UNITED STATES PATENT AND TRADEMARK OFFICE

APPLICATION NO.	FILING DATE	FIRST NAMED INVENTOR	ATTORNEY DOCKET NO.	CONFIRMATION NO.
10/791,997	03/02/2004	Daniel J. Coster	APL1P290/P3186	4300

Office Action Summary	Application No. 10/791,997	Applicant(s) COSTER ET AL. 	
	Examiner Zachary M. Pape	Art Unit 2835

DETAILED ACTION

Fig 1

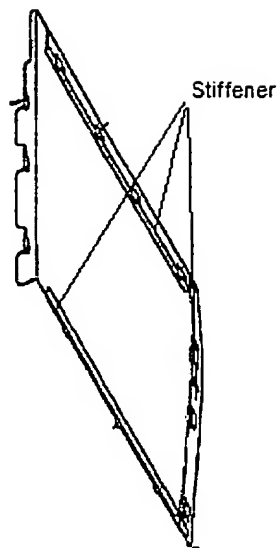
With respect to claim 38, as best can be understood by the examiner, Chen et al. further teaches a stiffener (See present office action Fig 1 below) that is attached to an inner surface of the planar access door, the stiffener being configured for insertion into a recess within the access opening when the access door covers the access opening.
